1 HVAC ROOF DEMO PLAN - SECTOR A
 DM2.1 SCALE: 1/16"=1'-0"

1 -ADDENDUM #2
 2/22/2018

SHERWOOD HIGH SCHOOL

1 HVAC ROOF DEMO PLAN-SECTOR C
DM2.3 SCALE: 1/16"=1'-0"

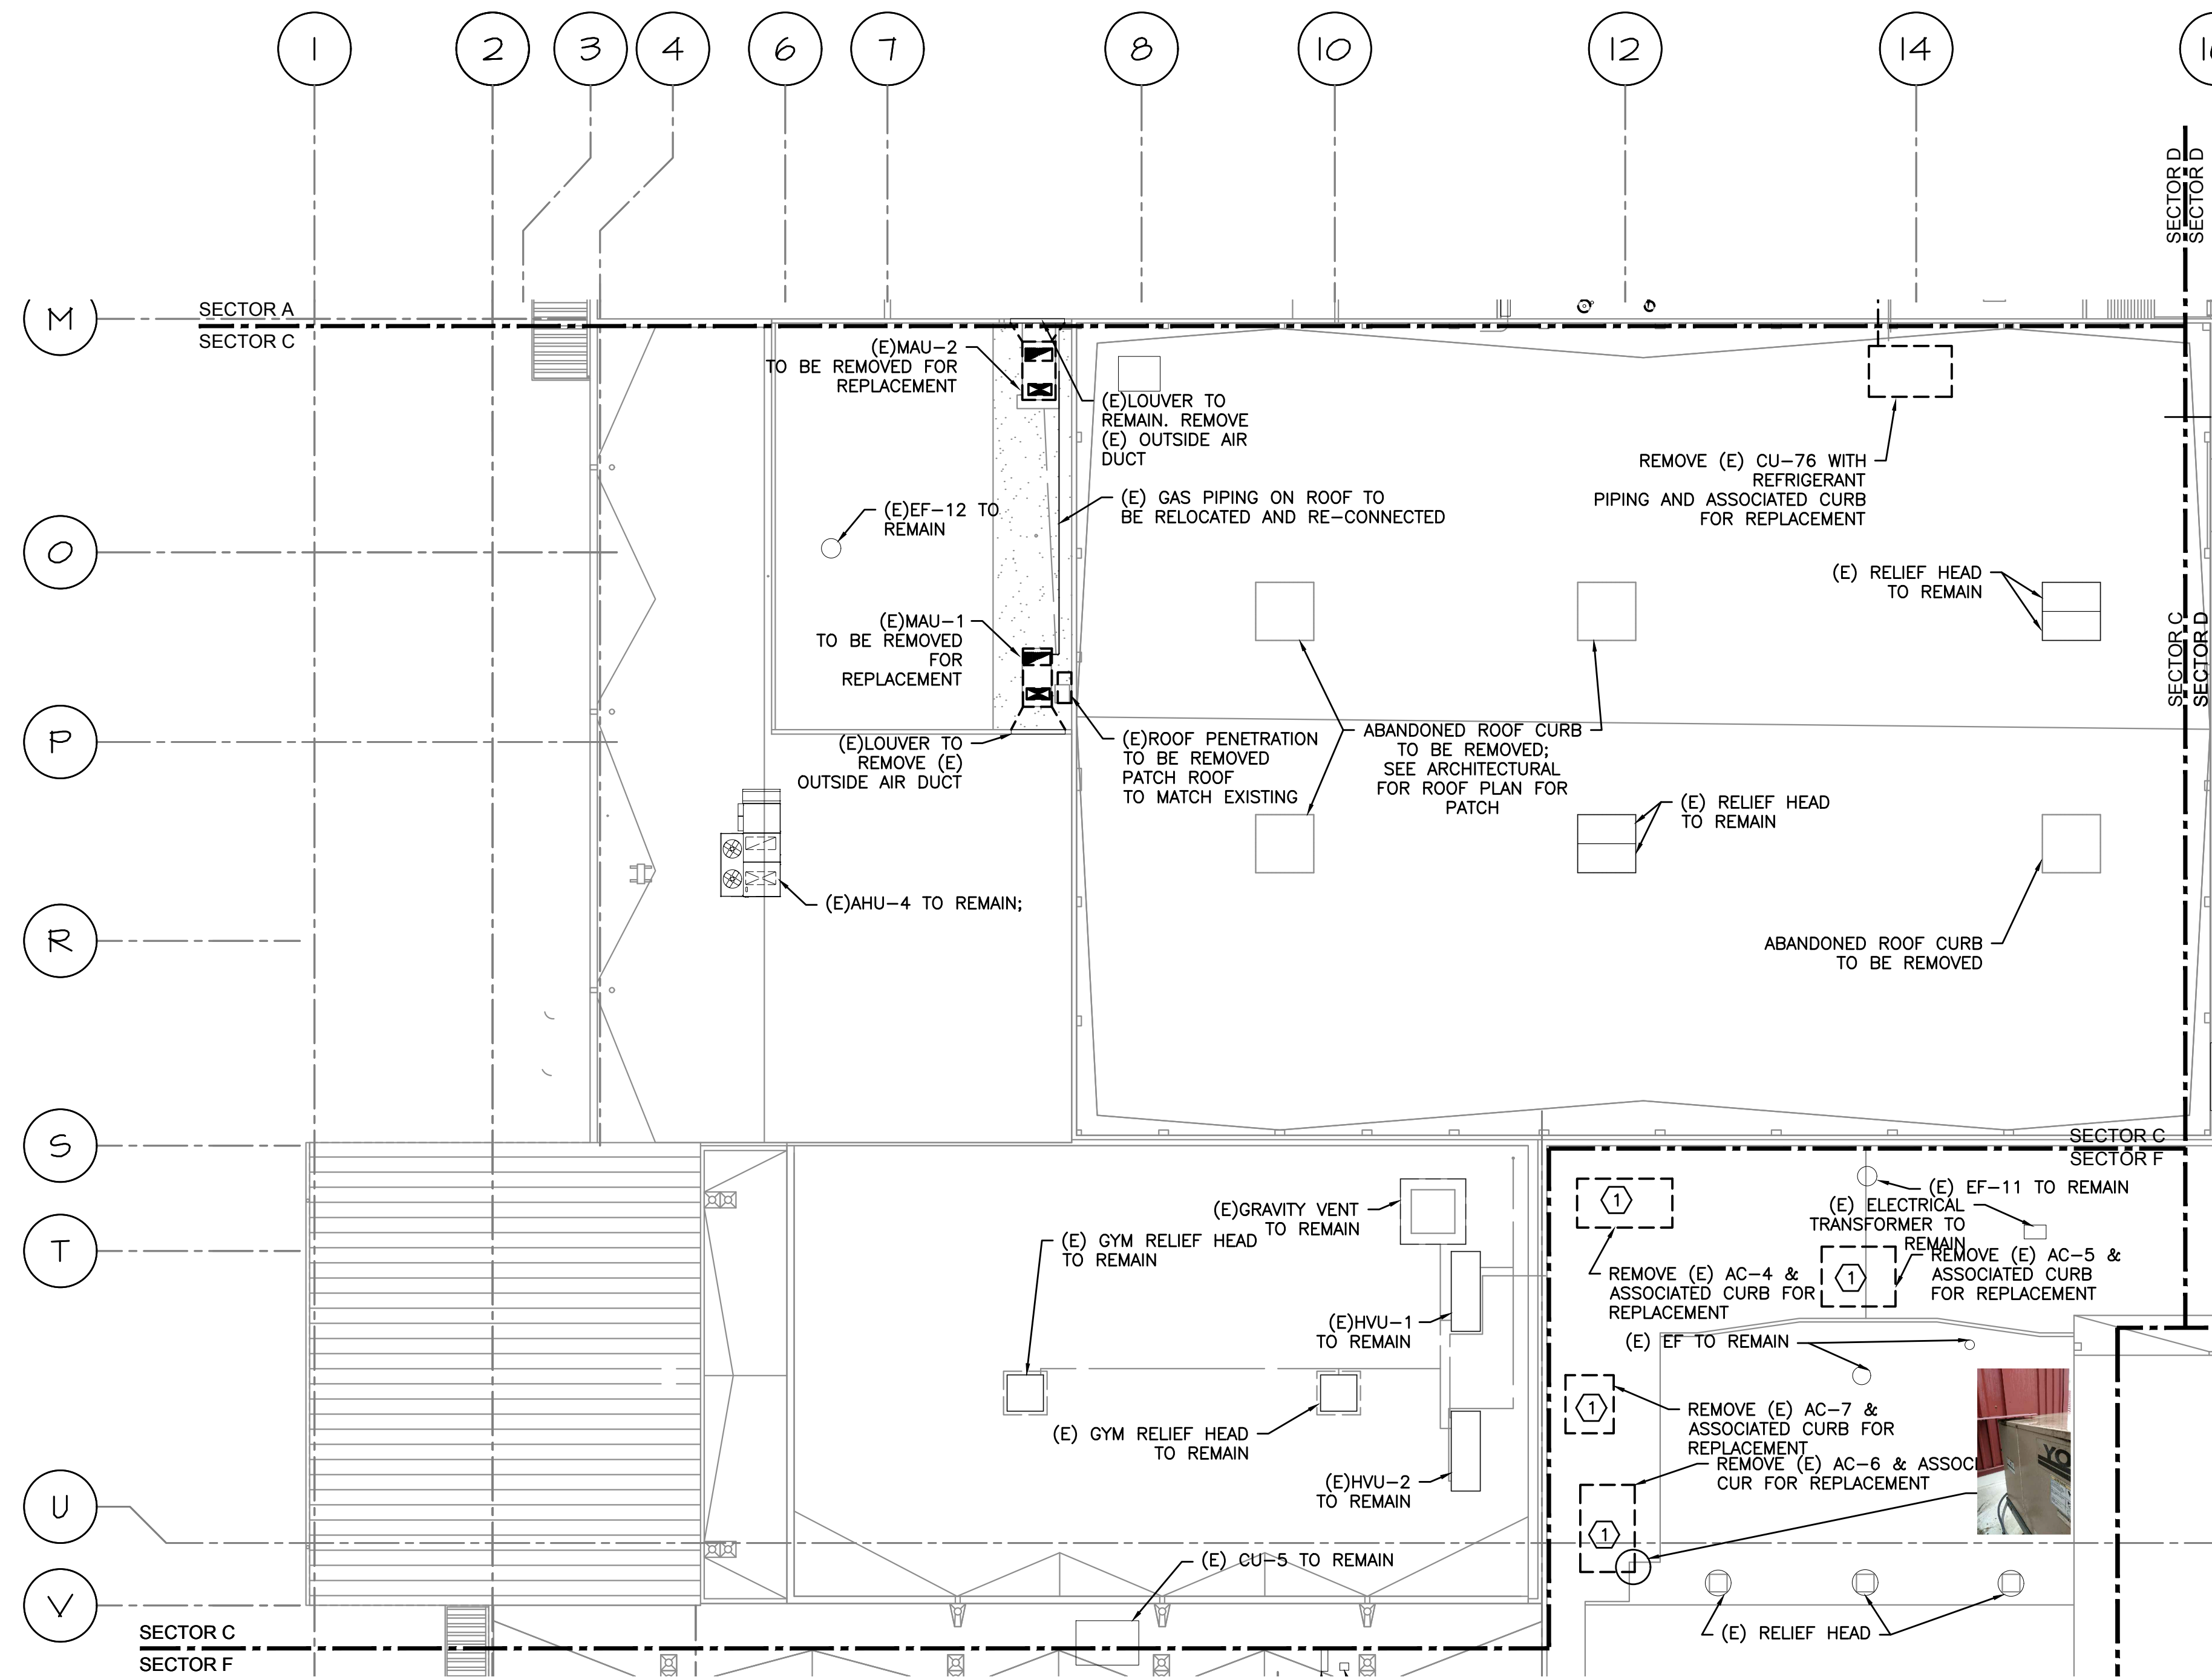
① - SALVAGE AUTOMATED LOGIC CONTROLLER FOR RE-USE IN NEW UNIT.
